Battery Lane District, Sketch Plan No. 320190080

Completed: 12.02.19

Summary

Figure 4 – Applicant proposed conceptual layout for Site D

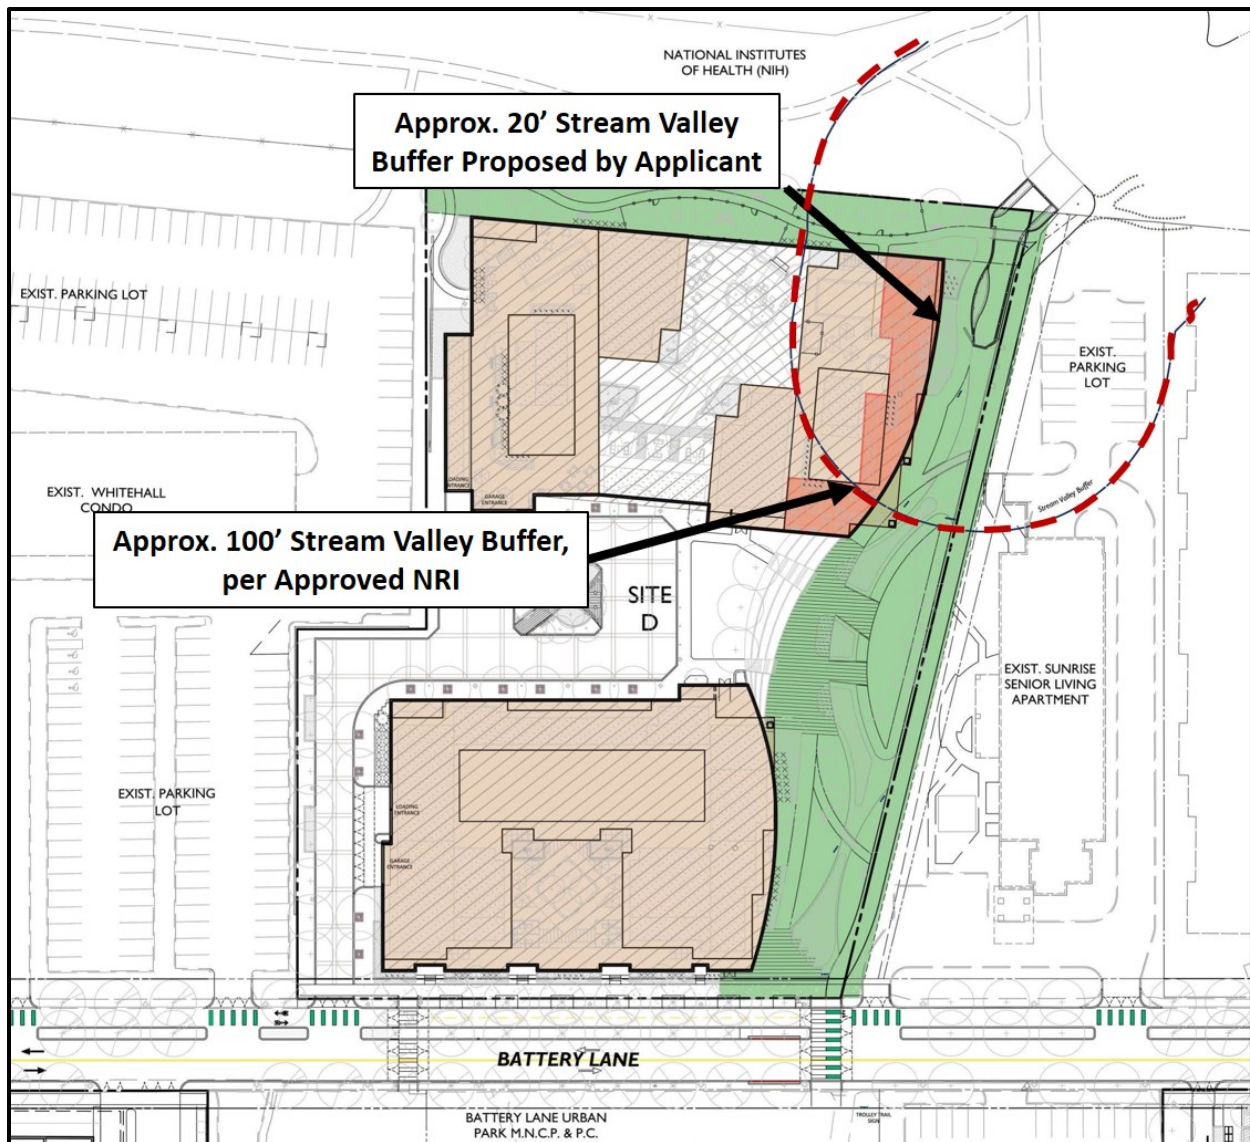
in this open space. The Applicant states that daylighting of the stream is infeasible due to the depth and size of the piped stream. The pipe is approximately 66 inches in width and varies in depth from the existing grade, between 7.5' and 10' below existing grade.

The Montgomery County *Environmental Guidelines* requires new development to maintain a 100-foot stream valley buffer, only allowing limited encroachments into the buffer for bicycle, pedestrian and other stormwater facilities. The Applicant proposes encroaching within the buffer, providing a 20-foot building setback from the stream, with other enhancements of the existing streambed, including a new headwall and other structural elements. At Sketch Plan, the Planning Board does not make findings relative to the stream valley buffer, however given the relation of the stream valley buffer with the Sector Plan recommendations for an enhanced open space, this is a major point of discussion within the Staff Report. Staff recommends a condition that would require the Applicant to explore increasing the width of the linear park to an average of 95 feet, allowing the width to increase and decrease along the site. A second condition would require the Applicant to minimize encroachment into the stream valley

buffer, and to provide mitigation for any unavoidable encroachments as specified in the Montgomery County Environmental Guidelines.

- c. Site D (4949 Battery Lane)
 - i. Submit alternative designs that explore each of the following for Sector Plan Conformance:
 - a. In coordination with applicable County agencies, determine the feasibility of daylighting the piped stream;

Figure 5 - Applicant Proposed Separated Bike Facility on north side of Battery Lane looking west

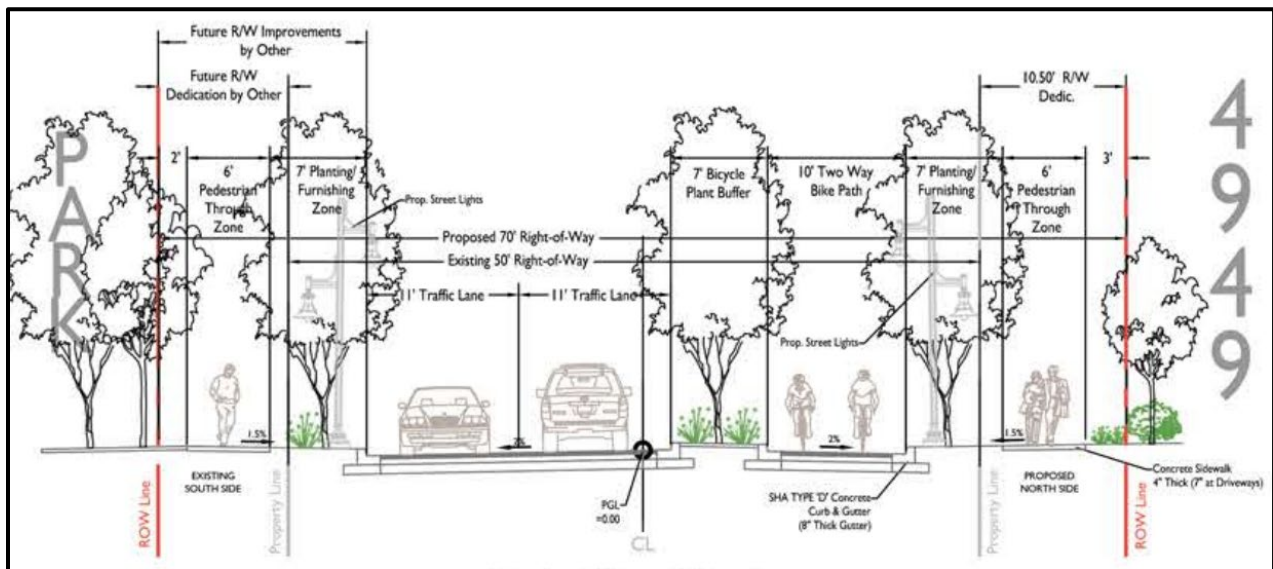
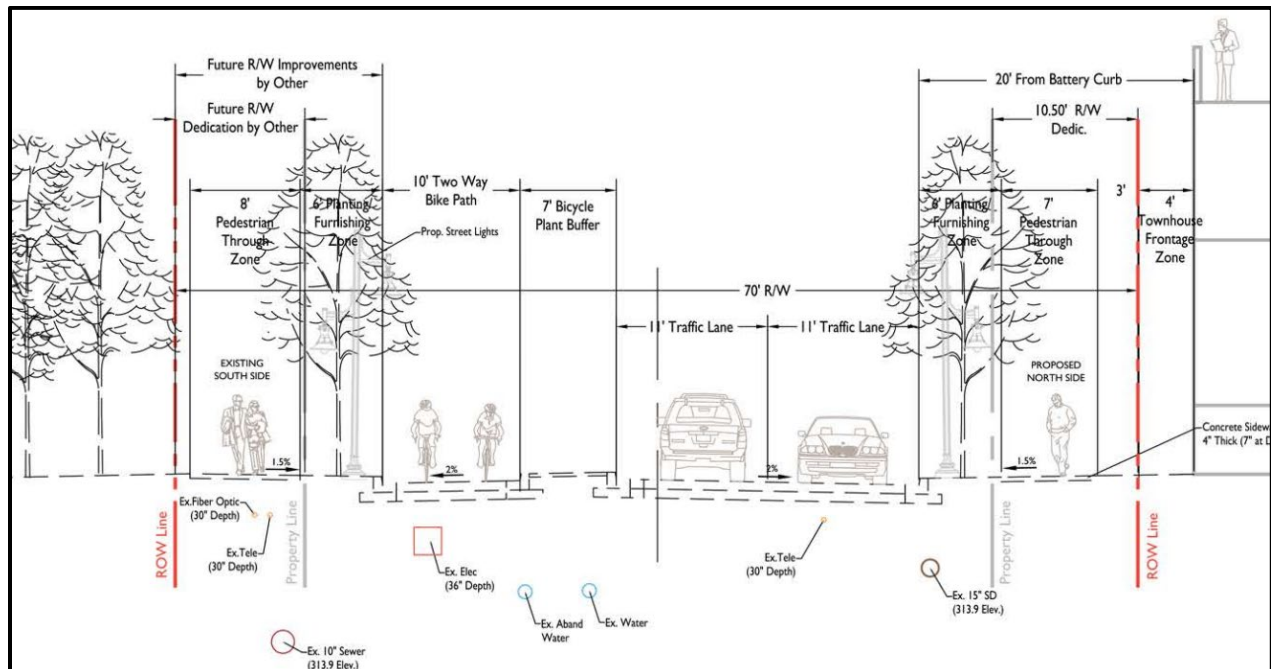
Based on the recommendations contained within the 2018 *Bicycle Master Plan* (Master Plan) and the recently approved development in the vicinity, Staff has determined the south side achieves maximum continuity. Locating the bike lanes on the north side of the road, as proposed by the Applicant, would require bicyclists to cross two legs of the intersection of Battery Lane and Woodmont Avenue to continue east-west travel, increasing bicyclist delay and exposure to motor vehicle traffic (see Figure 7). Furthermore, constructing the separated bike lanes on the north side of Battery Lane would preclude the construction of a protected intersection at this busy intersection, given that the property on the northwest corner has recently redeveloped.

The Applicant states that existing water lines along the south side of Battery Lane may preclude the planting of trees within the proposed 7' buffer if the separated bicycle lanes are constructed on the Staff preferred south side. While the addition of trees in the buffer would add canopy to the right-of-way, a tree lined median is not a requirement or recommendation of the Master Plan or Sector Plan. Under both designs submitted by the Applicant, the separated bicycle lanes would meet the design criteria recommended in the Master Plan. The Staff preferred alternative better addresses bicycle comfort, simplifies the alignment and reduces vehicular conflict. For these reasons, Staff recommends a condition requiring the bike lanes to be located on the south side.

Figure 6 - Staff Recommended Separated Bike Facility on south side of Battery Lane looking west

Figure 18 - Proposed Site D with 100' stream valley buffer

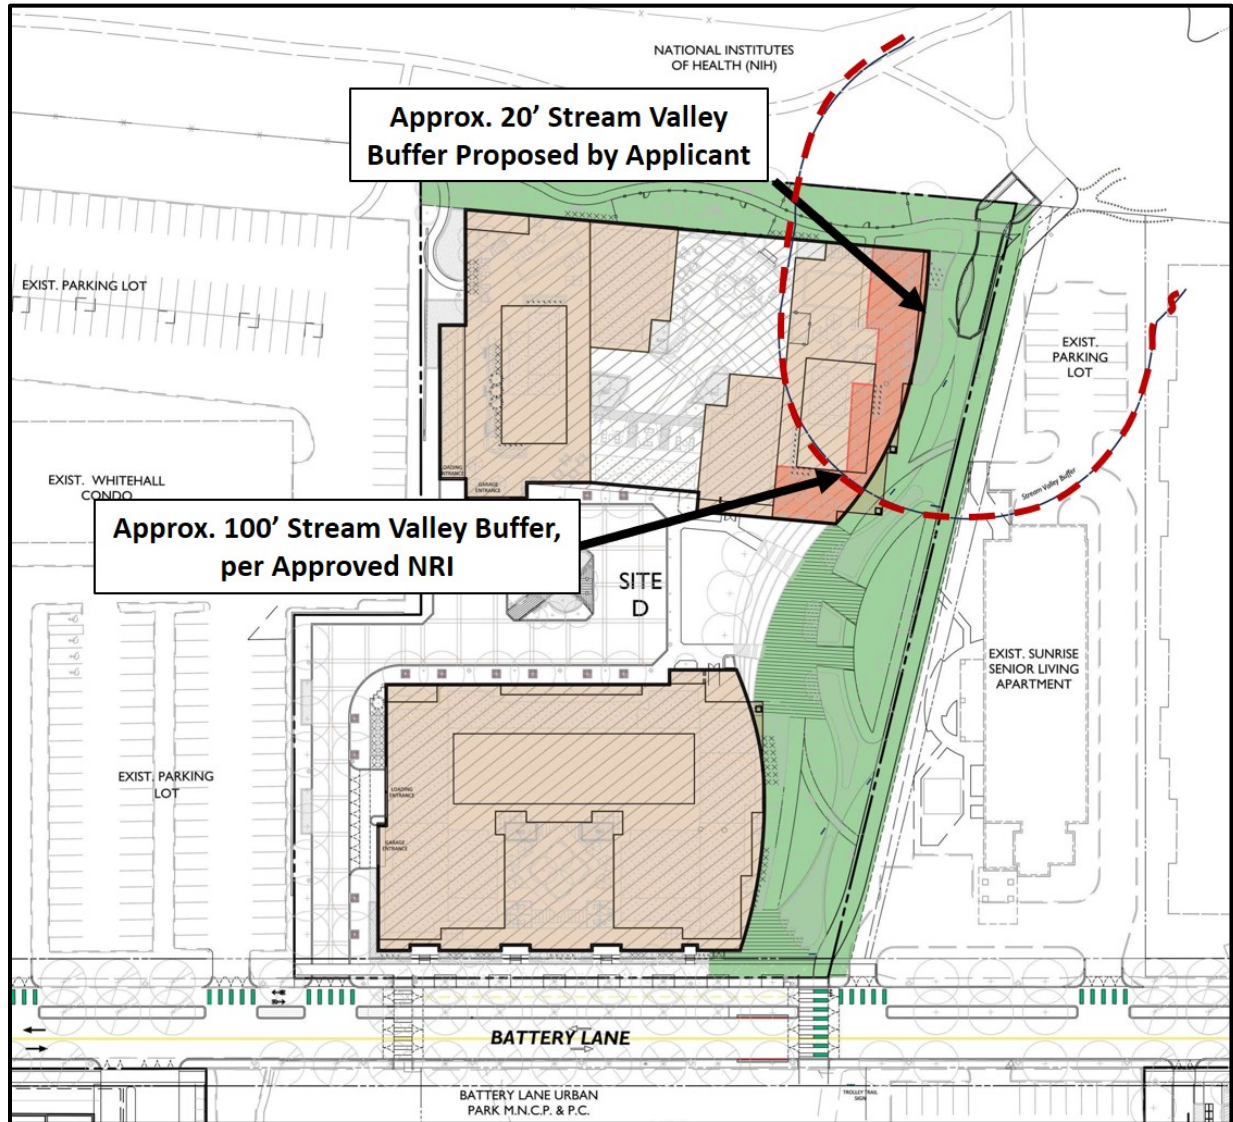
The Applicant proposes a mixed-use building at the rear of Site D adjacent to a proposed open space. Generally, the size of this space is smaller than the Sector Plan recommended 0.9 acres, at 0.58 acres, and the width is smaller with an average 60 feet. Pursuant to Sector Plan recommendations, Staff is recommending the Applicant explore moving building footprints at the time of Site Plan in order to provide for an enlarged linear Urban Greenway with an average width of 95 feet to be more in keeping with the width and size of the linear greenway as portrayed in the referenced figures of the Sector Plan. The proposed condition would also require the Applicant to continue working with applicable County agencies to determine the feasibility of daylighting the stream. The Applicant has stated that daylighting of the stream is not feasible due to the size of the 66-inch pipe and the depth of the pipe below the existing grade. Figure 19 below shows sections of the existing piped stream at various points along Site D, as well as the proposed grading, stormwater elements, and headwall improvements proposed by the Applicant, in lieu of daylighting the stream.

The northernmost buildings proposed on this site overlap with the approximately 100-foot stream buffer (See Figure 18). Per Montgomery County Environmental Guidelines, no buildings or structures are permitted within stream buffers. Exceptions to this guideline may, however, be made for bikeways, trails, and infrastructural uses found to be necessary, unavoidable, and minimized.

Given that Site D is the largest of all five sites (3.05 acres), and the limited size and location of the stream valley buffer, a large developable footprint remains outside of the stream valley buffer. To date, the Applicant has not submitted any justification for encroachment into the stream valley buffer. Pursuant to Environmental Guidelines, Staff is recommending the Applicant revise Site D building placement and/or footprints in order to minimize and mitigate any encroachment into the Stream Valley Buffer. Staff acknowledges that the Project is located within an urban environment and therefore future constraints of the site may be identified. Any unavoidable encroachment into the stream valley buffer must be minimized and mitigated per Environmental Guidelines recommendations. Staff supports daylighting of the stream as potential mitigation for encroachment into the buffer, as illustrated in Figure 20 below, an increased building setback allows for an uninterrupted urban greenway that meets the Sector Plan urban green goals of interweaving the built and natural environments to make spaces livable for humans and all biota. Further, the ecosystem benefits provided by daylighting the piped stream, which include significantly increased stormwater capture; improved water quality; and increased biodiversity and habitat, are also directly linked to Sector Plan goals.

Figure 22 - Applicant Proposed Separated Bike Facility on north side of Battery Lane looking west

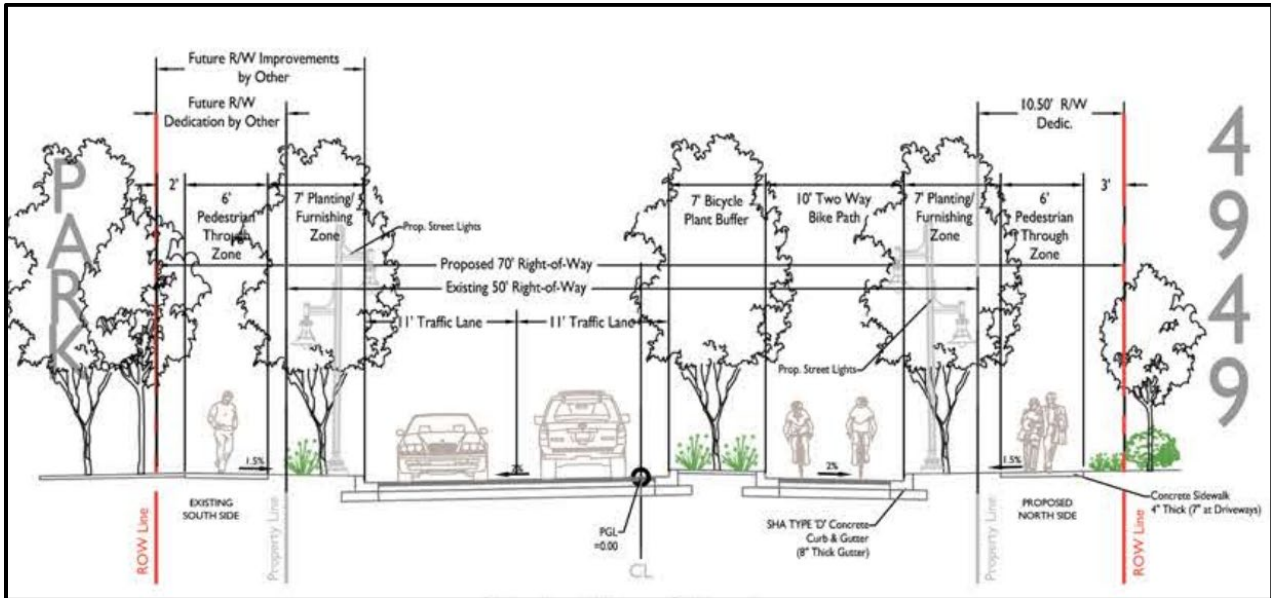
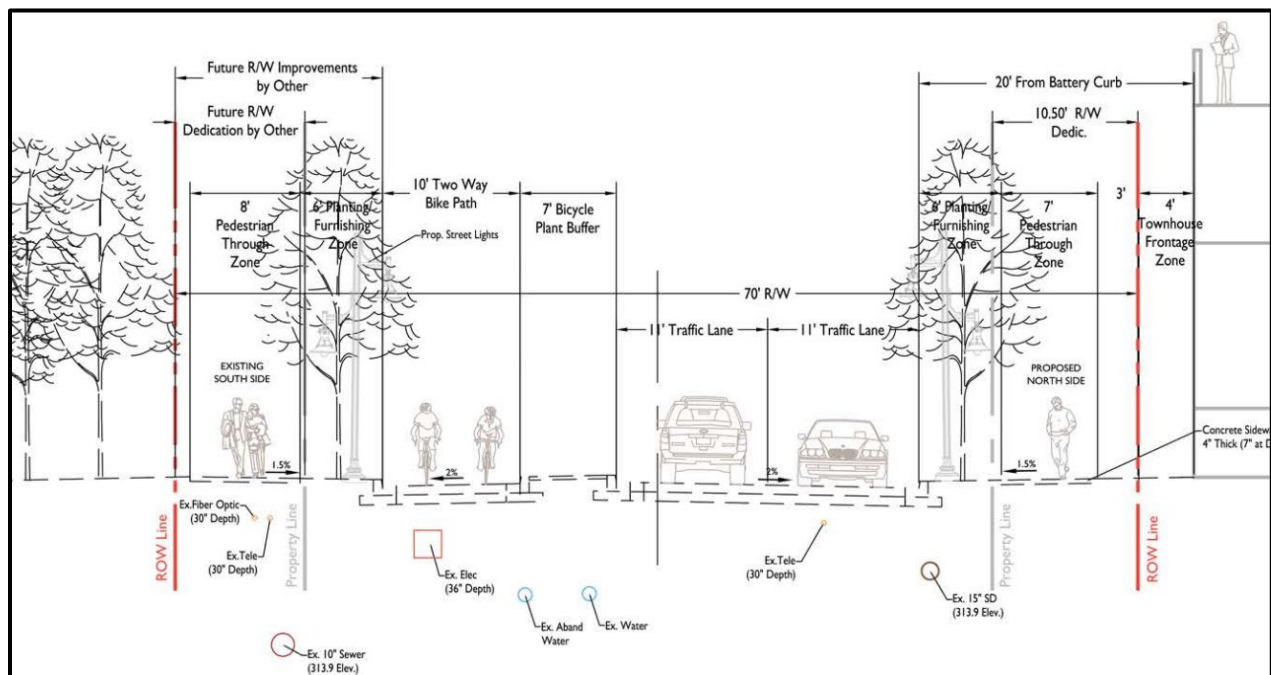
In coordination with Functional Planning and Policy, Staff reviewed the policies and recommendations of the 2018 *Bicycle Master Plan* (Master Plan) along with the recently approved development in the vicinity. The Master Plan indicates the separated bicycle lane location is “to be determined” for two of the three legs (See Figure 24 below), with the third leg being designated on the north side. The development approval located at 8280 Wisconsin Avenue studied the separated bike lanes on the north and south side of Battery Lane and found the south side to be the safest given the existing site constraints and the southern alignment of Rosedale Avenue. Further, the intersection of Wisconsin Avenue at Battery Lane and Rosedale Avenue is an offset intersection (i.e. the west and east legs of the intersection do not align), crossings from Battery Lane to Rosedale Avenue are far simpler if the bikeway is on the south side of Battery Lane. Given this network context, Staff has determined the south side achieves maximum continuity.

Locating the bike lanes on the north side of the road, as proposed by the Applicant, would require bicyclists to cross two legs of the intersection of Battery Lane and Woodmont Avenue to continue east-west travel, increasing bicyclist delay and exposure to motor vehicle traffic (see Figure 25). Furthermore, constructing the separated bike lanes on the north side of Battery Lane would preclude the construction of a protected intersection at this busy intersection, given that the property on the northwest corner has recently redeveloped.

Under either the design submitted by the Applicant or the Staff preferred alternative, the separated bicycle lanes would meet the design criteria recommended in the Master Plan. Although the Applicant’s preferred north side alignment would accommodate a new tree lined median between the separated bike lanes and the travel way, the addition of a tree lined median in the roadway complicates realization of the Master Plan goals to maximize bicycle comfort, simplify bicycle lane alignment, and reduce vehicular conflicts. The Staff preferred alternative better addresses bicycle comfort, simplifies the alignment and reduces vehicular conflict. For these reasons, Staff recommends a condition requiring the bike lanes to be located on the south side.

Figure 25 - Points of conflict for Applicant proposed north side separated bicycle lanes

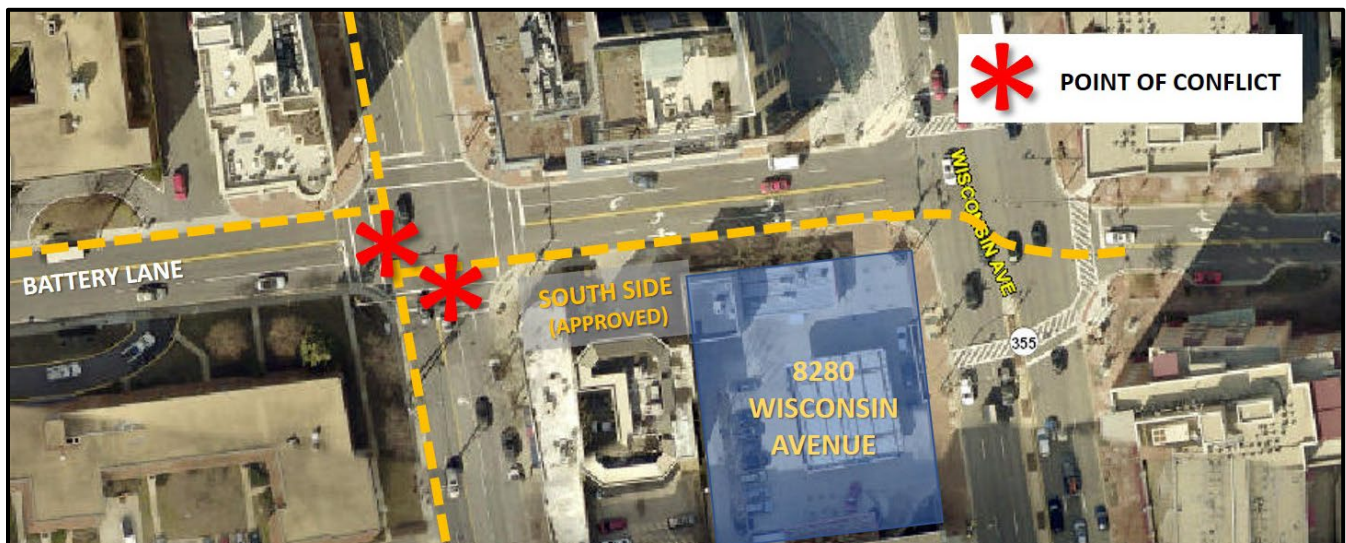
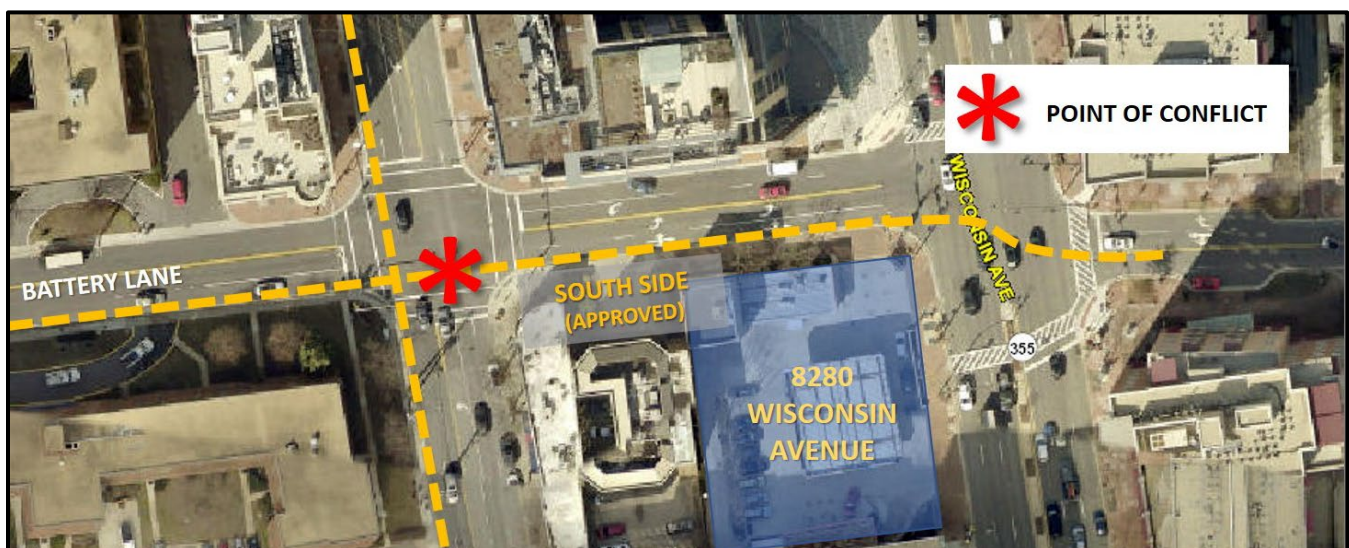
The Applicant has provided a “Pros and Cons” list for each alternative, contained in Attachment D. The Applicant states that existing water lines along the south side of Battery Lane may preclude the planting of trees within the proposed 7’ buffer if the separated bicycle lanes are constructed on the Staff preferred south side. While the addition of trees in the buffer would add canopy to the right-of-way, a tree lined median is not a requirement or recommendation of the Master Plan or Sector Plan. The canopy corridor goals of the Sector Plan are recommended to be achieved by planting street trees in the frontage zones outside of the roadway.
